SITE PLAN REVIEW

LOT NO 58..... REGISTERED PLAN 43M-1981.....

OSTIENSE
CITY OF BRAMPTON

SITING
CARL FINLAY DRIVE
LOT 58

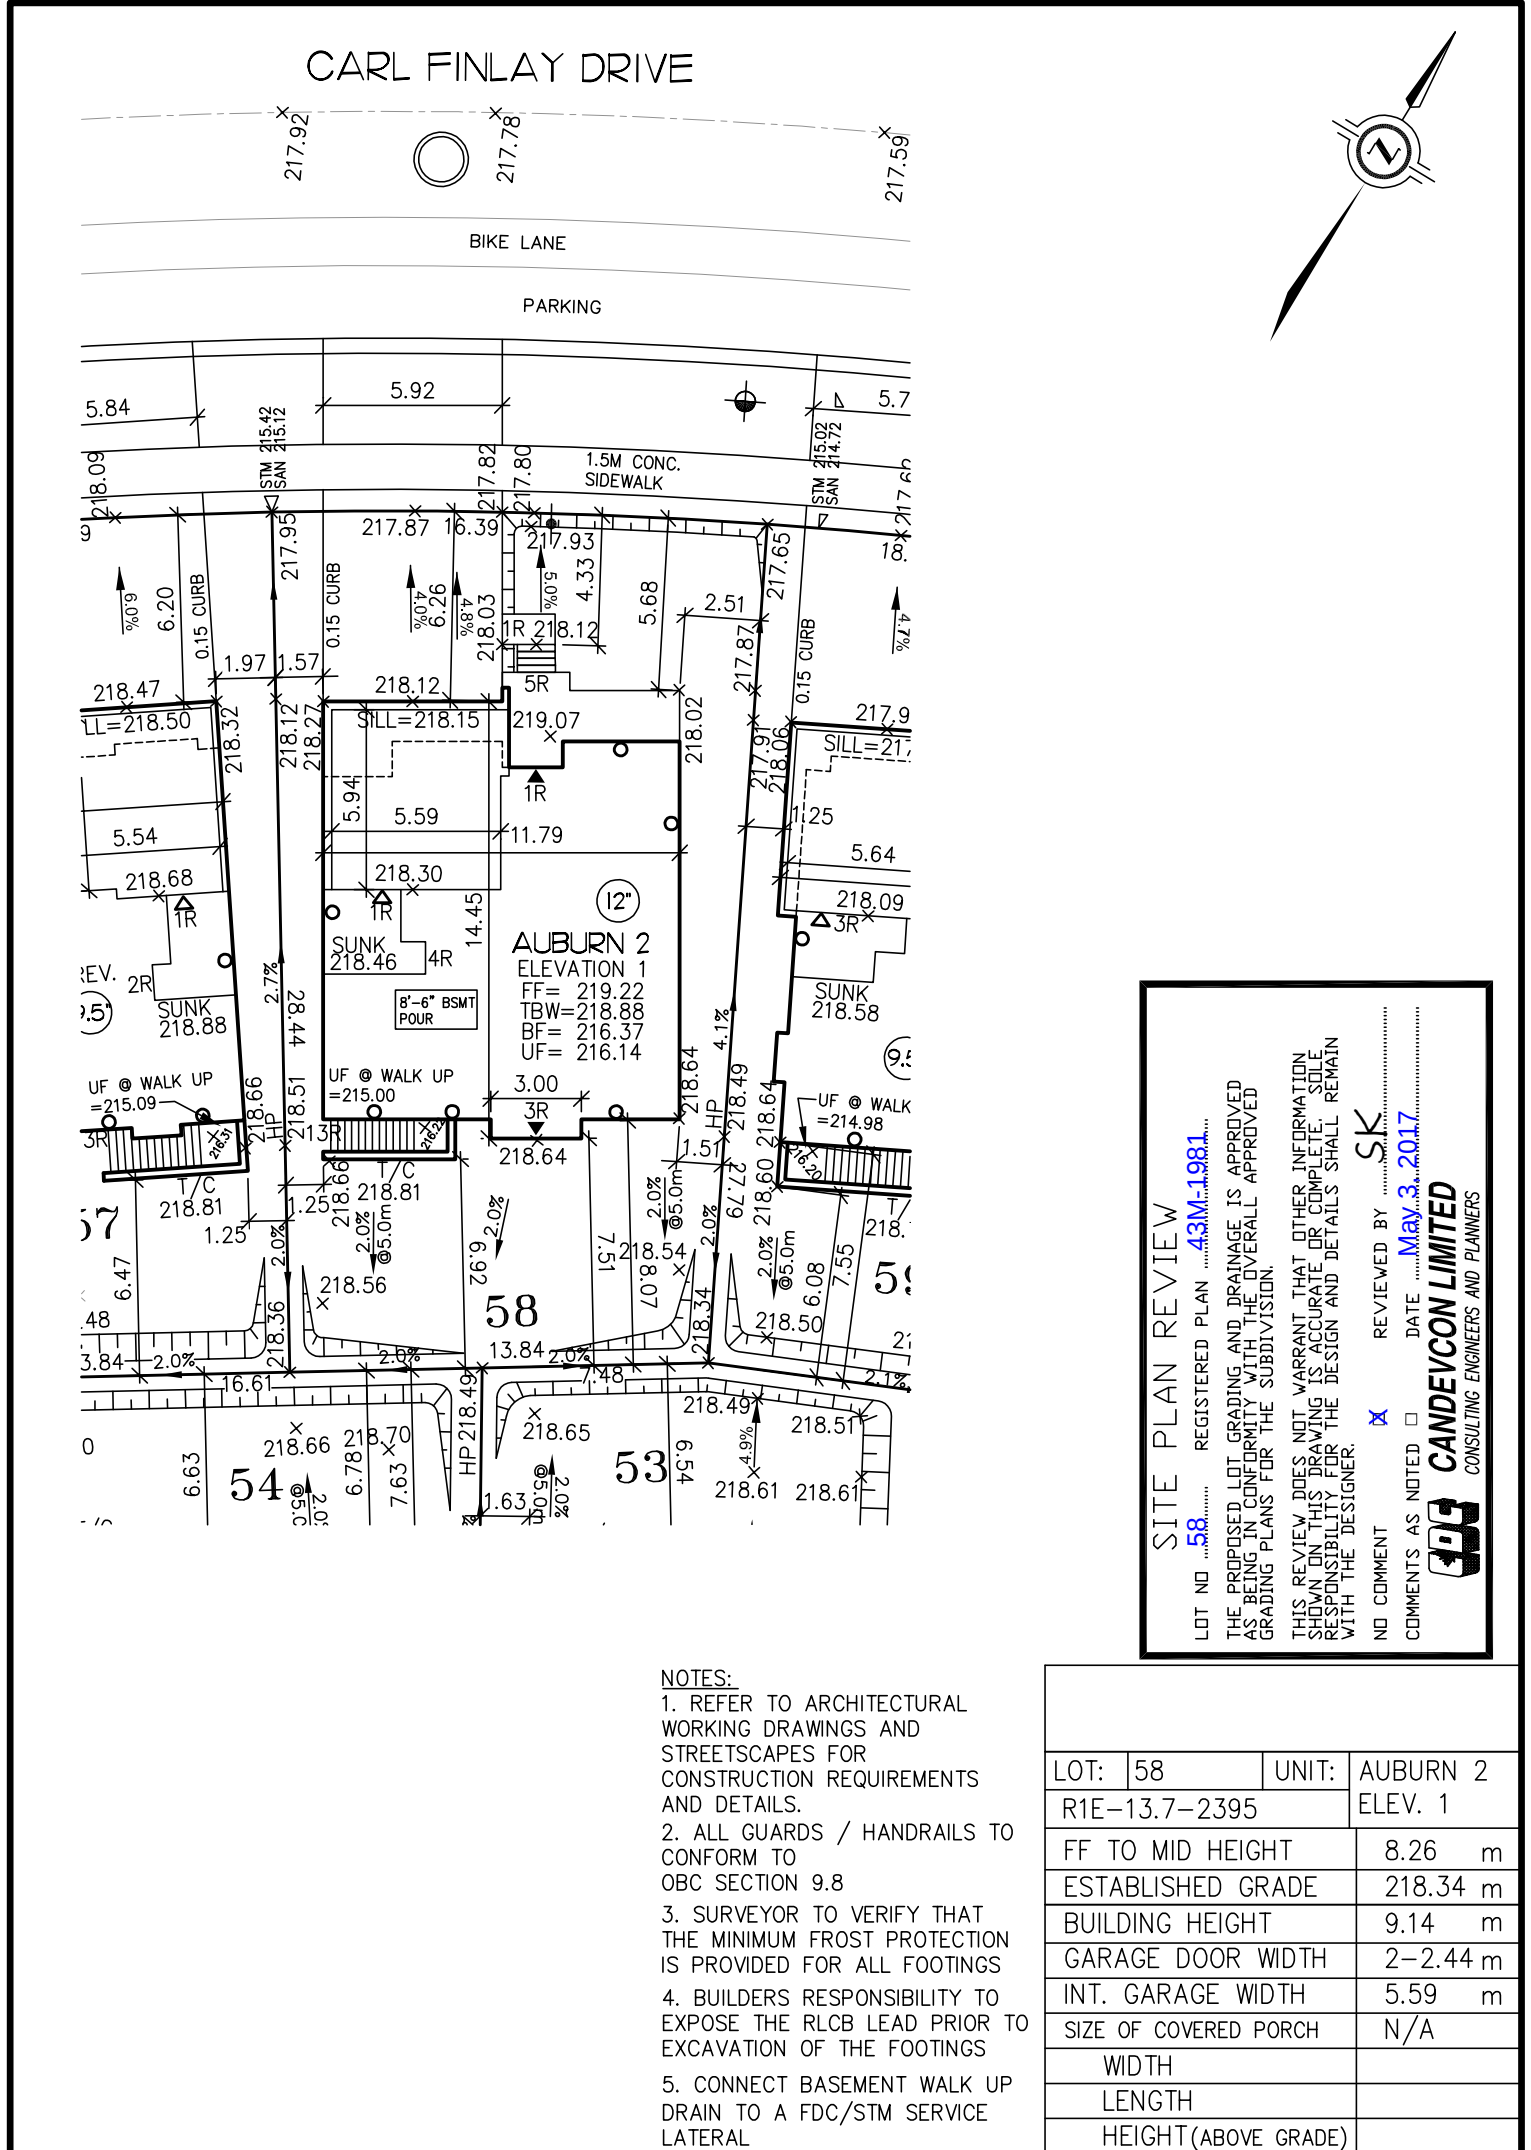
THE PROPOSED LOT GRADING AND DRAINAGE IS APPROVED AS BEING IN CONFORMITY WITH THE OVERALL APPROVED GRADING PLANS FOR THE SUBDIVISION.
